County of Santa Clara

FILE NUMBER: PLN21-114
SUBJECT: Building Site Approval on Slope 30% or Greater and Grading Approval
SITE LOCATION: 0 Helen Way, Los Gatos, CA, 95033 (APN: 544-39-035)
DATE RECEIVED: June 20, 2023 (resubmittal)

Your application for Building Site Approval on Slopes 30% or Greater and Special Permit have received on the above date and is deemed **incomplete**. For the application processing to resume, you must resolve the following issues and submit the information listed below.

Fig. 4.20-2
Parking Structure
—Sloping Lots

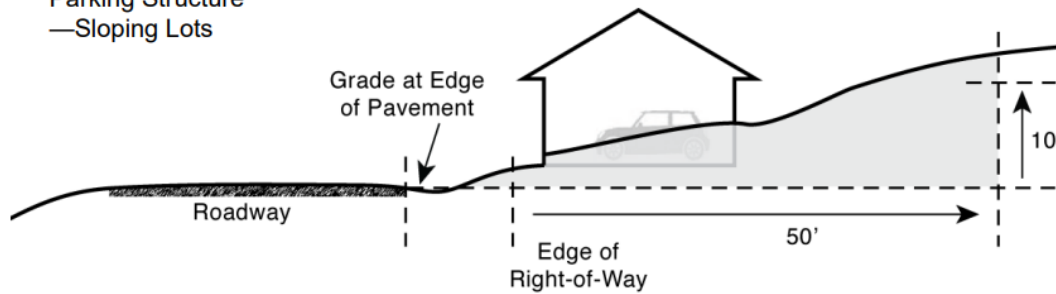
- a. A section drawing cutting through the Redwood Drive roadway and the proposed garage. The section cut shall extend a minimum of 50-feet beyond the edge of the right-of-way. Pursuant to Zoning Ordinance 4.20.020.(F).(1), *“Where the grade elevation at a point 50 horizontal feet inward from the edge of right-of-way differs 10 vertical feet or more from the elevation at the adjacent edge of pavement, a garage, carport or other parking structure may be located within the required front or side yard of a lot.”*(see Fig 4.20-2 inserted from Zoning Ordinance).

Please see section
A-A
